Task# 60280

340 1st Avenue East, Dyersville, Iowa 52040 · Phone: 563-875-7724 · Fax: 563-875-8238 www.cityofdyersville.com FENCE PERMIT ZONING DISTRICT R-1FLOOD PLAIN: YES \times NO This Fence Permit is hereby issued to William Rubinsum
(Name)

Subject: 2025-0508: Other Structures, Obstructions, Fill, Spoil, Deposits: We propose to install a 4' high chain link fence from the rear of the house and garage 150' long along east and

RE: Fencing Application

ArcGIS Web Map

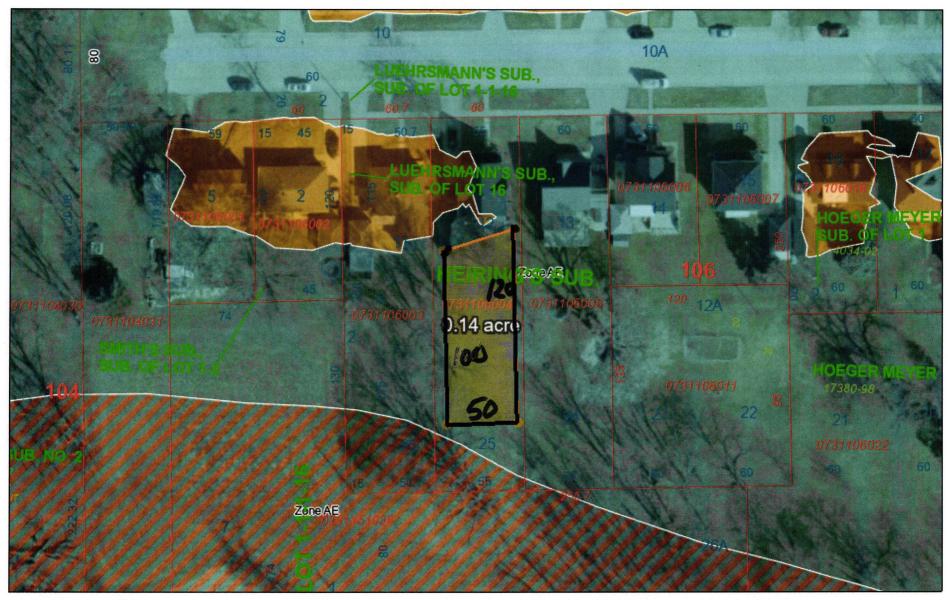
I am reviewing the above referenced project for approval by the Iowa DNR. We do not allow fences within the floodway (red/blue hatched area shown below). No structure/fill/spoil material can be placed within the floodway either.

Please send me a drawing on an aerial map showing that the fence will not extend into the floodway with dimensions matching what I am showing below (measured from the front property line.

Task Log				
Entry Date	Employee	Log Entry		
4/4/2025	Michel	I reviewed fence permit 25-04 and Section 165.09.11 of the City		
		Code. The property is located in the flood fringe and flood way.		
		The fence meets the minimum code requirements, but it		
		requires an approved floodplain development permit.
